ACCESSION NBR: 9708010147 DOC. DATE: 97/07/18 NOTARIZED: YES DOCKET #
 FACIL: STN-50-528 Palo Verde Nuclear Station, Unit 1, Arizona Publi 05000528
 STN-50-529 Palo Verde Nuclear Station, Unit 2, Arizona Publi 05000529
 STN-50-530 Palo Verde Nuclear Station, Unit 3, Arizona Publi 05000530

SUBJECT: Responds to 970422 RAI re improved TS Section 3.4, "RCS." Proposed TS encl.

Response to Request for Additional Information

Figure 3.4.17-1 (page 1 of 1)
Reactor Coolant DOSE EQUIVALENT I-131 Specific Activity Limit
Versus Percent of RATED THERMAL POWER With Reactor Coolant
Specific Activity > 1.0 $\mu\text{Ci/gm}$ DOSE EQUIVALENT I-131

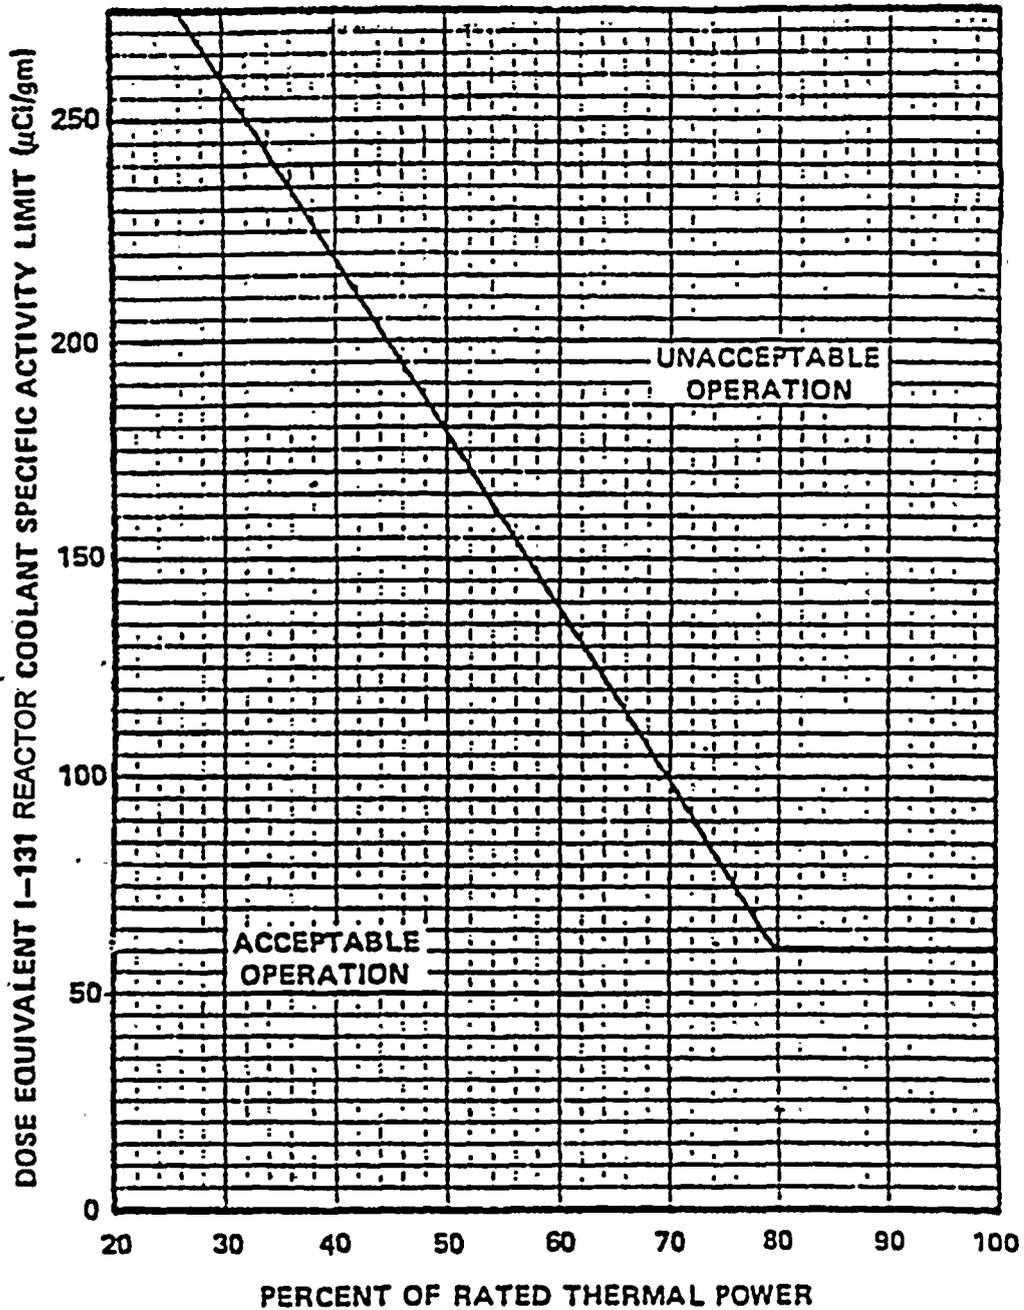
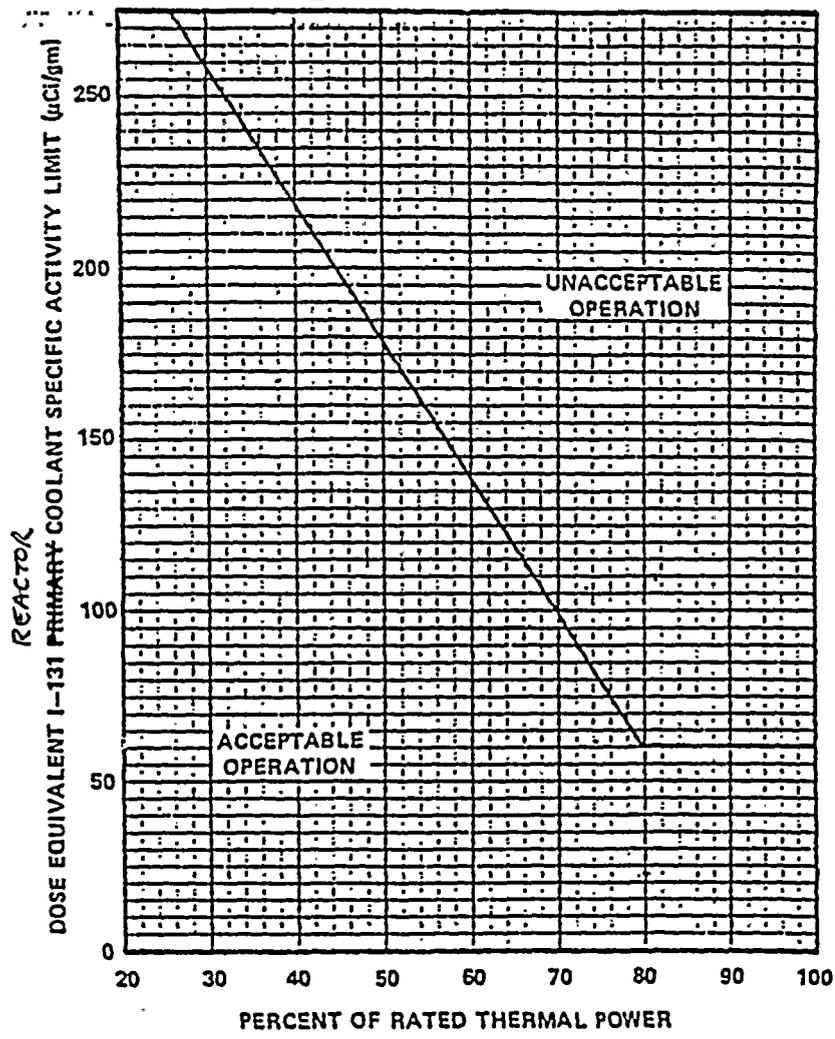
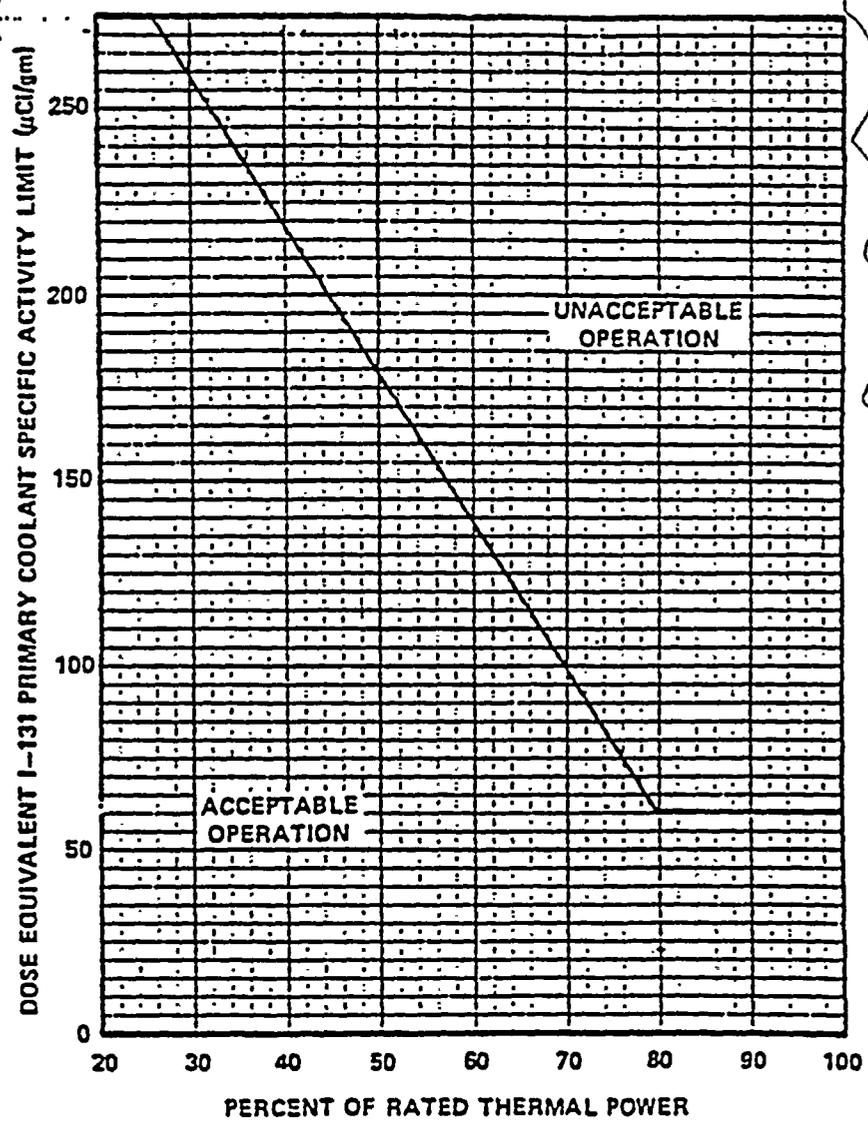
3.4-17-3	None	ITS Figure 3.4-1 (Smooth Copy)	The ITS Figure 3.4-1 (Smooth Copy) does not match the CTS Figure 3.4-1. The horizontal line at 80% power dividing acceptable and unacceptable operation appears to be at "65" rather than the intended "60". Also, "reactor coolant" is used instead of "primary coolant" in three places.	The limit curve in ITS Figure 3.417-1, has been revised to accurately reflect the corresponding CTS Figure 3.4-1. The term "Primary Coolant" in CTS Figure 3.4-1 is changed to "Reactor Coolant" in ITS Figure 3.4.17-1 as an administrative editorial change to be consistent with the terminology in ITS LCO 3.4.17 and NUREG-1432 3.4.16. Note that CTS uses "reactor coolant" and primary coolant" synonymously, as shown by CTS 3.4.6 (reactor coolant system chemistry) and CTS 3.4.7 (primary coolant specific activity). NUREG-1432 and ITS corrects this mixing of terminology by using "reactor coolant" exclusively.

3.4.1-1
FIGURE 3.2-1 (INSERT)
REACTOR COOLANT COLD LEG
TEMPERATURE VS. CORE
POWER LEVEL

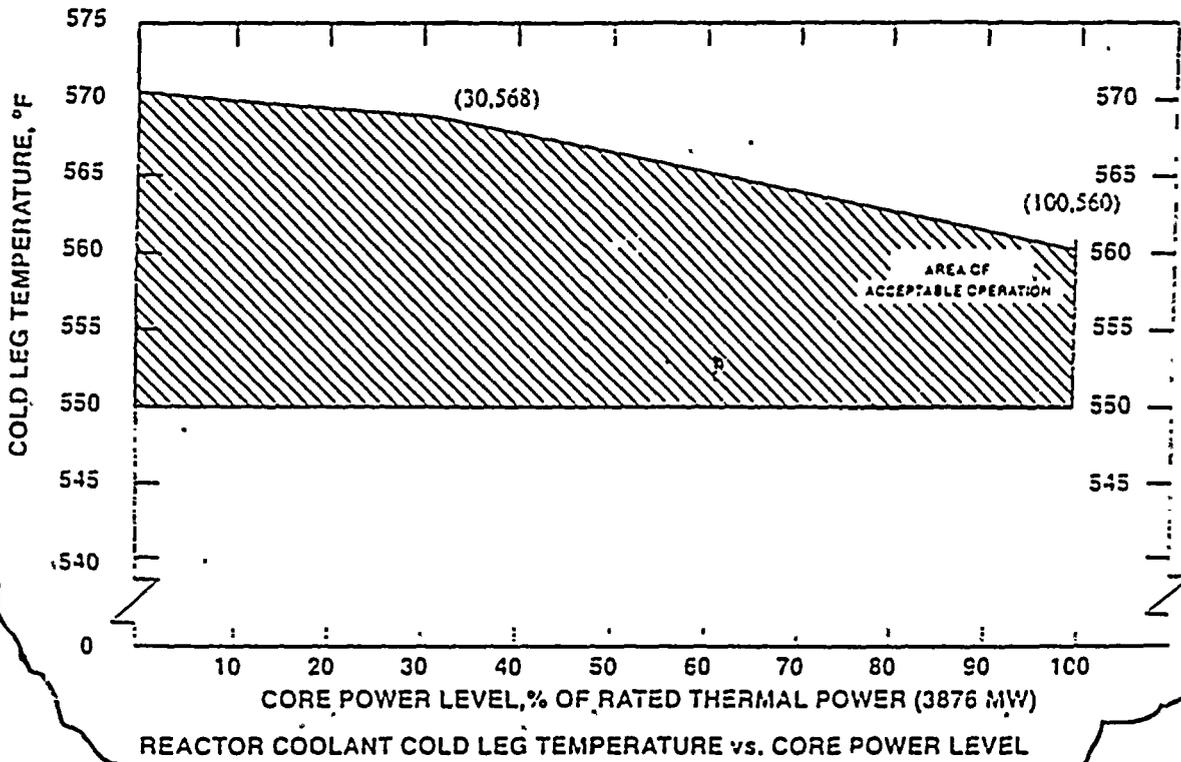
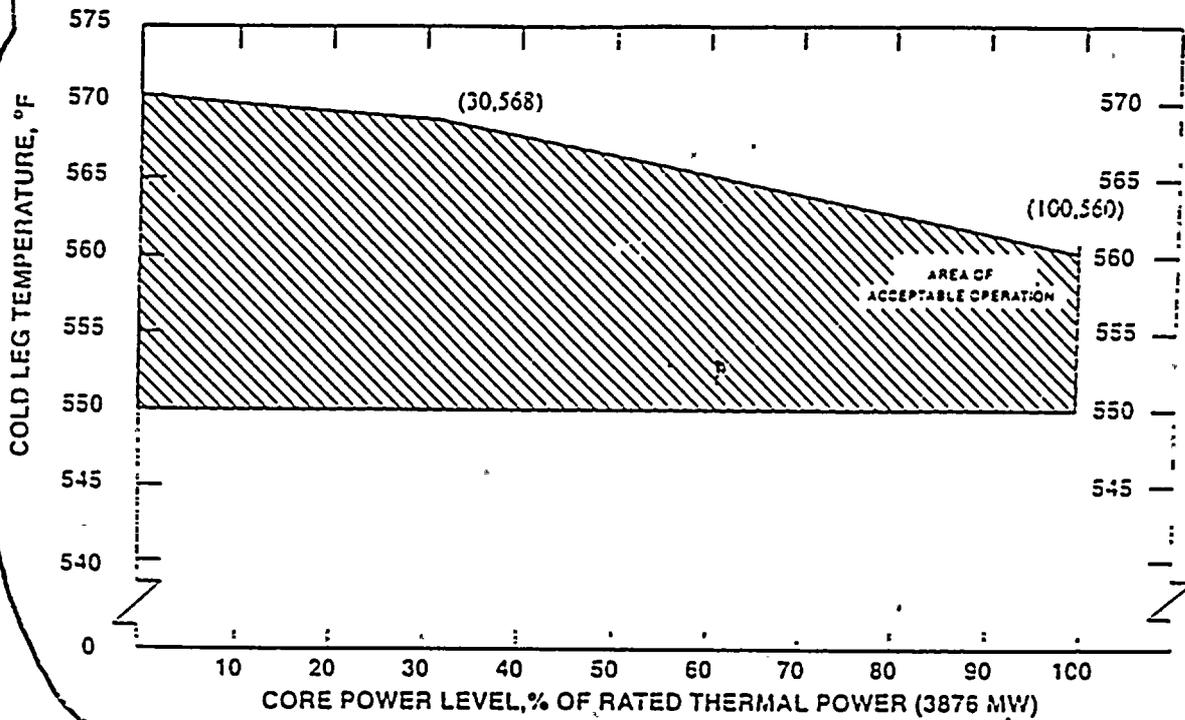
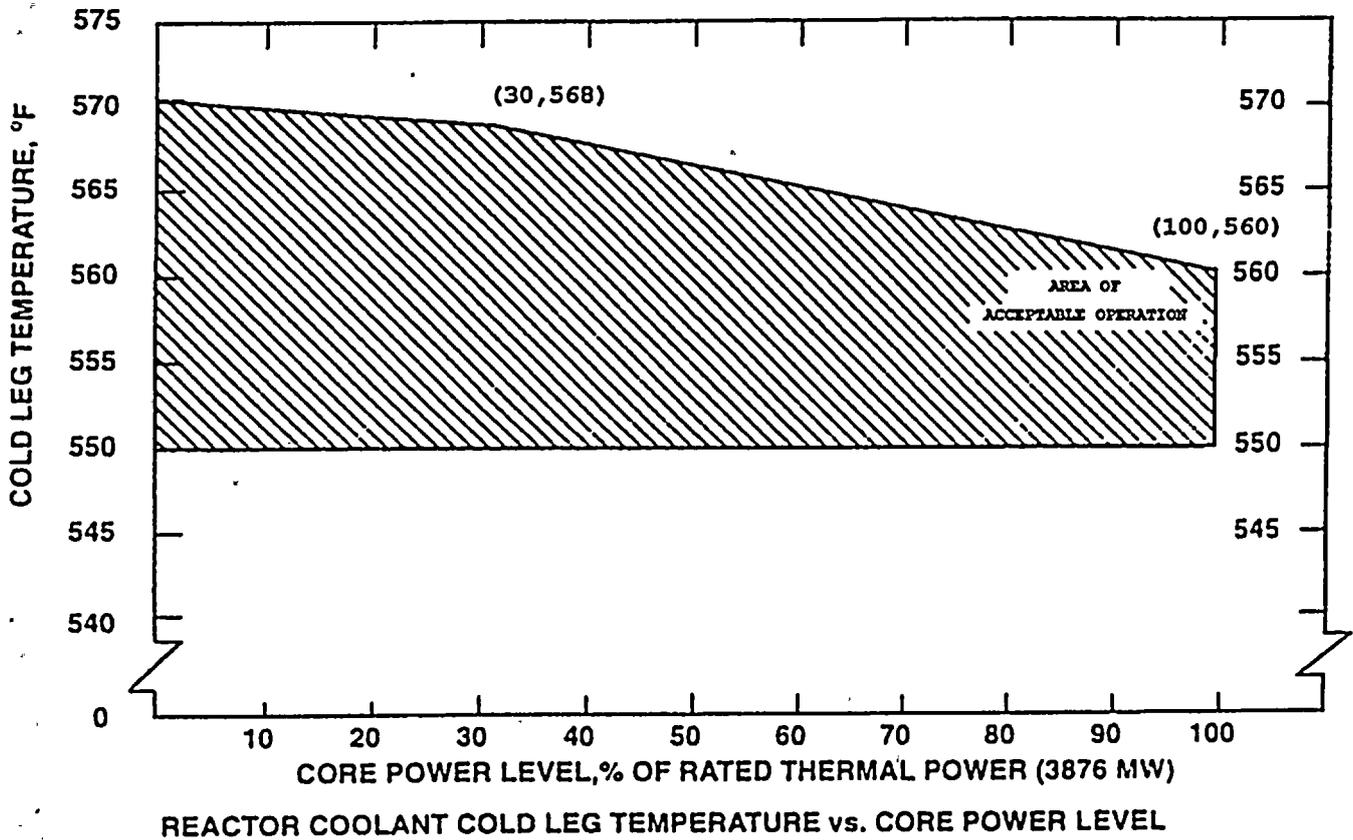
ISSUE #	DOC # or JFD #	CTS/STS REF	DESCRIPTION OF ISSUE	PVNGS RESPONSES
3.4.1-1	A.3	CTS Figure 3.2-1 ITS Figure 3.4-1	DOC A.3 states "CTS 3.2.6, Figure 3.2-1, for Units 1, 2, and 3 is modified per TS Amendments No. 108, 100 and 80 for PVNGS Units 1,2 and 3 respectively, related to power uprate." What is the change? This DOC can not be evaluated because the change is not identified. Also, the "endpoint" value of "100,560" is missing in the ITS "smooth" copy Figure.	<p>1) DOC A.3 has been deleted. The referenced license amendments have been fully implemented and ITS Figure 3.4.1-1 is the same as CTS Figure 3.2-1.</p> <p>2) ITS Figure 3.4.1-1 has been enhanced to include the end point values of "100, 560" as shown on CTS Figure 3.2-1.</p>
